Karst Hydrogeology of the Georgia Power Plant Hammond Surface Impoundment AP-3, Floyd
County, Georgia, and Impacts on the Fate and Transport of Coal Combustion Residuals

Submitted to

Ms. Dori Jaffe
Sierra Club
50 F St NW, Washington, DC 20001

September 10, 2021

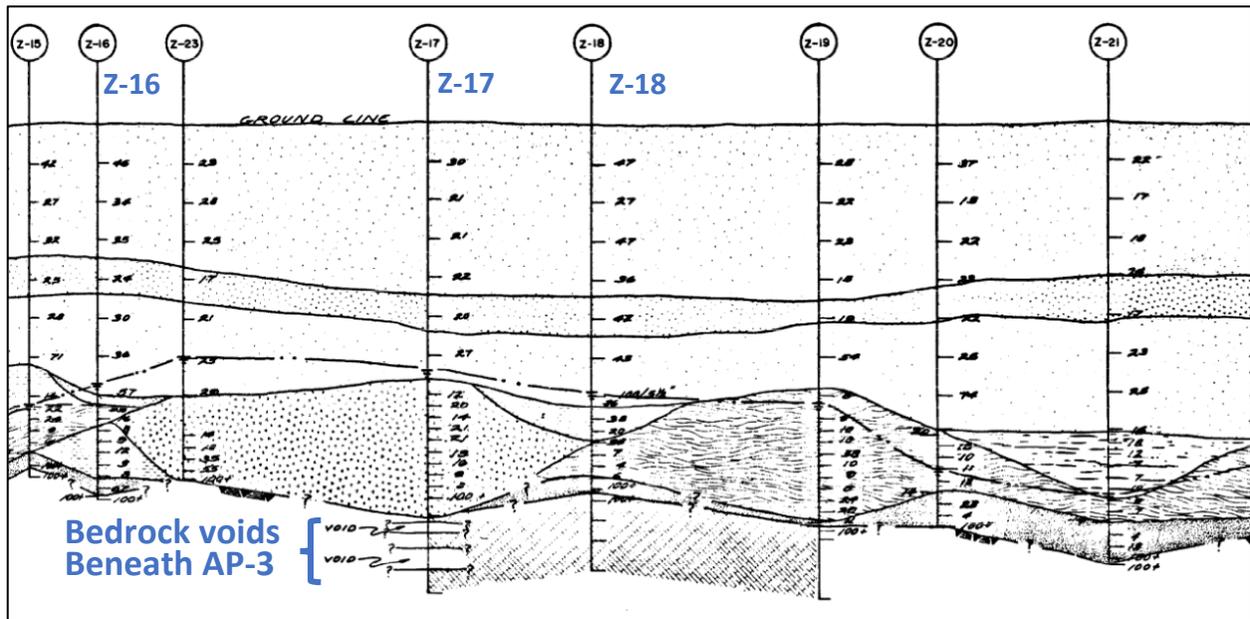
Although it is true that at the resolution of the topographic maps (Part B Application pdf p. 31) shown for the sites there is no apparent expression of surface karst features, the subsurface investigations show *extensive* dissolution of the limestone beneath the site. Boring Z-17 in the 1977 sketch below (Figure 4) was made prior to AP-3 becoming operational, and shows several voids (the white spaces indicated at the bottom of the drawing indicate voids or space rather than solid rock) that were encountered in the bedrock. Although the boring log from Z-17 in the drawing (and thus the date it was drilled) is missing from the Part B Application, the logs from the Z-series borings that are included, including Z-16 to the left Z-18 to the right, were made in December 1976 and January 1977, several months before AP-3 became operational (Part B Application, pdf pp. 104-112). The planners knew there were voids in the limestone beneath AP-3 *before* CCR disposal was initiated.

Another round of subsurface investigation followed in August 1977, based on drill logs by GPC Civil Division Materials Section (Part B Application, pdf p. 99 and p. 102-103), with more voids encountered, as shown for example below in Figure 5.

Figure 7. topographic map of AP-3 from a drawing dated November, 1979 (Part B Application pdf p. 1272). Showing the of location of a sinkhole. Added blue circle highlights the area of sinkhole.

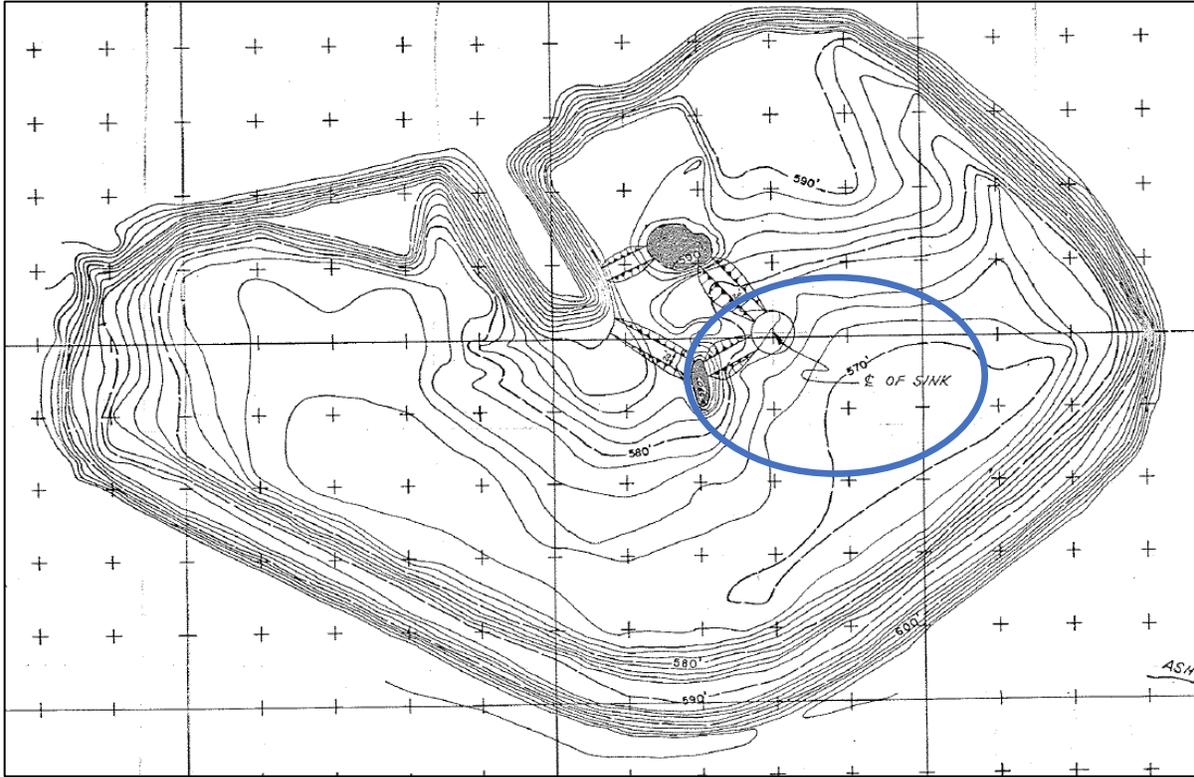
One month after initiation of CCR disposal in June, 1977, on July 20 a major loss of CCR, estimated at one million gallons per day, occurred with the development of a sinkhole beneath AP-3 (Figures 7 and 8). This event was described as follows, the euphemistic term “seepage” notwithstanding (2010 Safety Assessment):

Not only does this show that a major, well developed karst aquifer lies beneath AP-3, but also the seepage represented a major groundwater contamination of CCR into this aquifer, any

Although the Part B Application narrative fails to mention the existence of any sinkholes under AP-3, over 1,200 pages into the document a November 1979, annotated March 10, 1980 diagram shows plans for repair of a large (58 feet across) sinkhole. While records (2010 Safety Assessment) indicate that after the 1977 sinkhole at AP-3 was returned to service in October 1977, this 1979 diagram is labeled as a “Plan of *Proposed* Sinkhole Repair” (emphasis added). Therefore, this appears to be a second *major instability* event at AP-3.

Figure 8. Details of proposed sinkhole repair for the same drawing as that from Figure 7 Indicating that the sinkhole was 58 feet in diameter (Part B Application, pdf p. 1272).

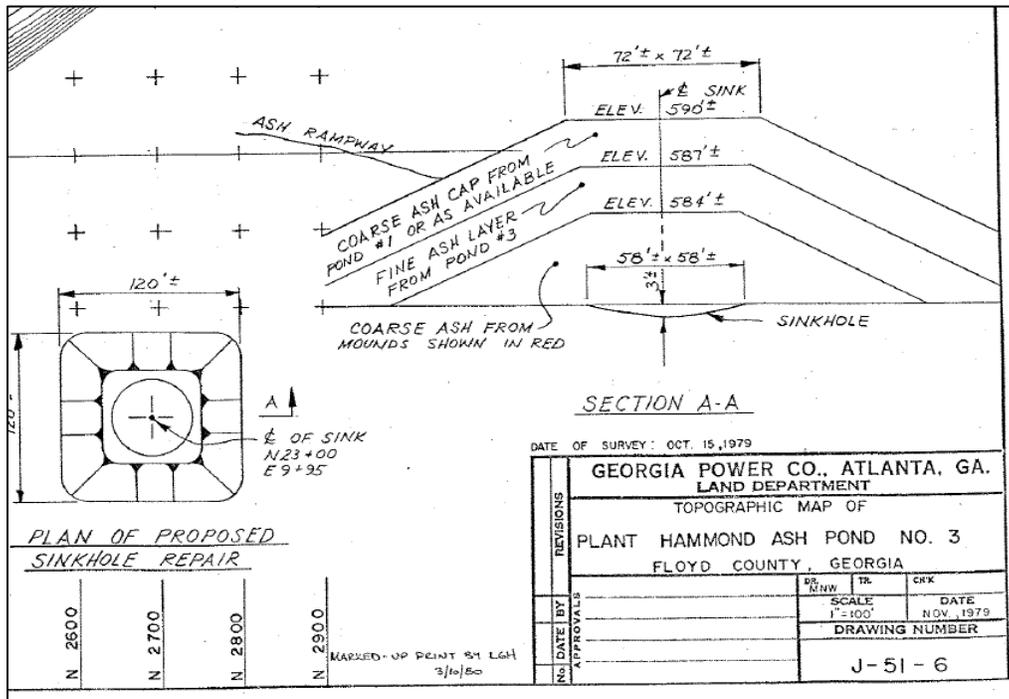
This is consistent with the narrative from the 2010 Safety Assessment (pdf p. 62) which states that “An interoffice memo dated March 14, 1980, indicate a sinkhole investigation at Ash Pond No. 3 was performed and recommendations were submitted.” This date, four days after the handwritten date in Figure 8, makes it appear that these refer to the same feature.

Records also indicate that another large sinkhole, 58 feet in diameter, opened up beneath AP-3 and was remediated, possibly, in 1979-80.

Indeed, although these structural instabilities may perhaps have been the motivation for the facility to switch operations to dry-ash handling, discussion of these collapse events *were wholly omitted from the narrative of the application.* Indeed, the only indication that this had ever happened at all shows up on diagram, included in the application without explanation, more than 1,200 pages into the document.

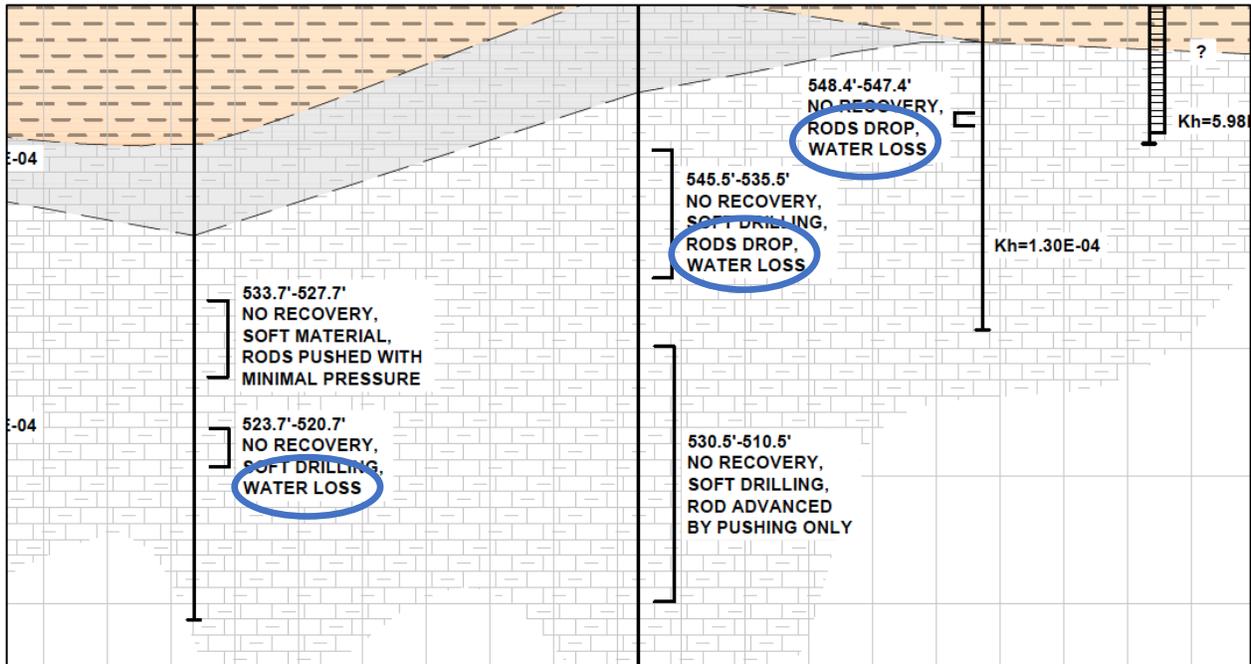
This same error occurs in the reporting of the conductivity of the Conasauga Limestone, with the same result that the reported mean is lower than what the data themselves clearly show. To explore this, we can consider the question of how hydrogeologists deal with values, like in well P-4 discussed above, with very high values of conductivity, which is what happens when a fracture or conduit is encountered, as in the numerous places where “drilling water was lost” at AP-C (Figure 9). Compared to the rock surrounding the fracture and conduits, the conductivity in such cases is typically so high it can be hard to measure, as discussed above for well P-4 in the Law Engineering Report. *Certainly, the answer is not to ignore these data*, as was done in Georgia Power’s application.

In summary, in the karst aquifer, which has been abundantly documented *by the data* to exist in the Conasauga beneath Plant Hammond, while the low, reported hydraulic conductivity of 4.46×10^{-4} cm/s may be a fine value to characterize the relatively impermeable rock between the fractures and conduits of the Conasauga Limestone, that's not where the water is flowing and it therefore provides a misleading, and indeed meaningless, characterization of the flow through the aquifer as a whole.

Figure 10. Cross section C-C' with area of saturated ash, and the top of the saturated zone, or water table, labeled.

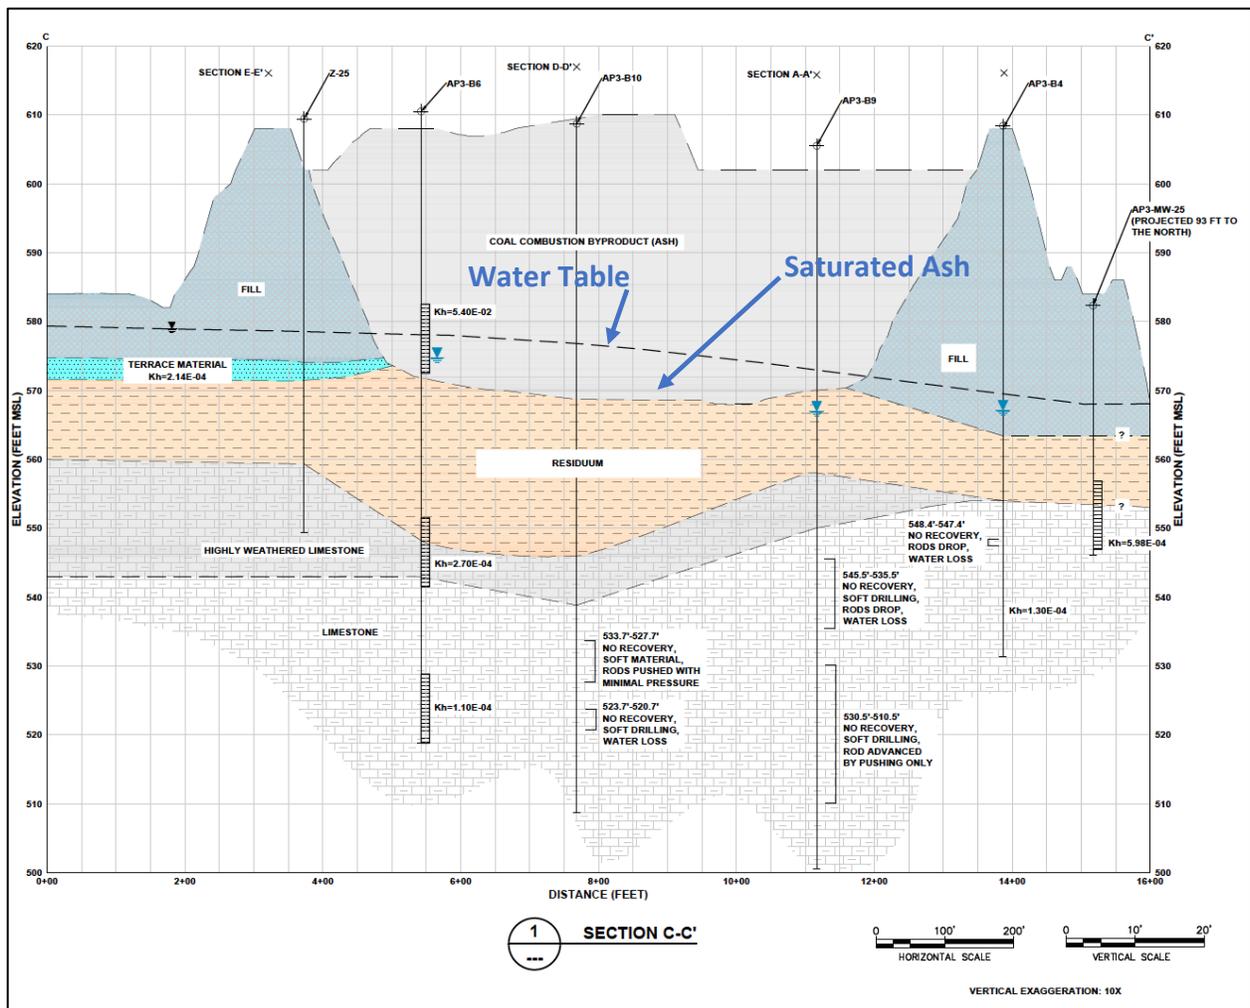
A cap over the ash footprint is designed to prevent vertical infiltration from above. However, as shown in Figures 1 and 2, sinkholes are not just induced from infiltration from above, but can form from the bottom up. As shown in the cross section below (Figure 10) the bottom part of the ash is saturated with groundwater. Each of the cross-section diagrams shows some material, either residuum or terrace material, between the ash and the limestone bedrock, which gives at least a visual sense of the materials acting as some kind of buffer, although there is no guarantee that the other unconsolidated material is itself is not subject to collapse into a sinkhole. The 1977 Law Engineering report (2010 Safety Assessment pdf p. 62) made it clear that this is not the case everywhere at A-3, apparently stating that the saturated ash was now sitting directly on top of the jointed (fractured) limestone bedrock:

possibility that water in the saturated ash moving vertically upwards and back down as storms pass through and the level of the Coosa River fluctuates could potentially drive CCR into the karst aquifer, with voids propagating upwards and loss of stability along the lines of the processes shown in Figures 1 and 2. In both cases the resulting sinkholes are initiated by loss of material from the bottom. Although water table data exist for the site, (Part B Application pdf p. 19) only a single day snapshot (June 4, 2018) has been provided and none with which to evaluate the rates or magnitudes of either storm or seasonal scale water table fluctuations.

Figure 11. Map showing eastward lateral groundwater flow beneath AP-3.

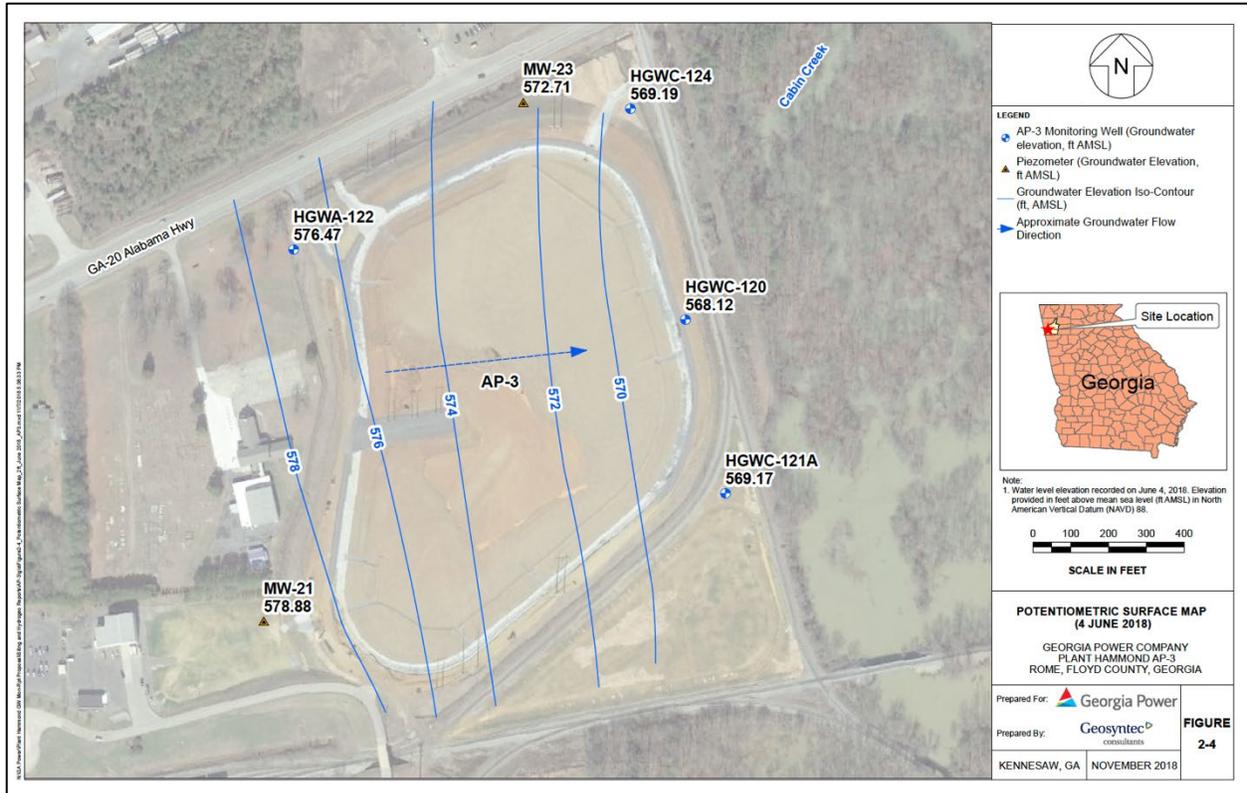
Although the cap will presumably prevent the vertical infiltration of rainwater from above moving downward, groundwater moves laterally beneath the site (Figure 11). While it would seem that a basic element to evaluate the stability of AP-3 would be a quantitative evaluation of the hydrology of vertical and lateral water flows beneath the site under storm and seasonal scale variation, other than a map of groundwater flow for a single, selected day, Georgia Power failed to provide this type of data in its application.

Some lateral groundwater flow velocities were provided, but not only are they potentially subject to the same analytical problems described in the discussions above, any discussion of flow velocities in the limestone bedrock is missing entirely.
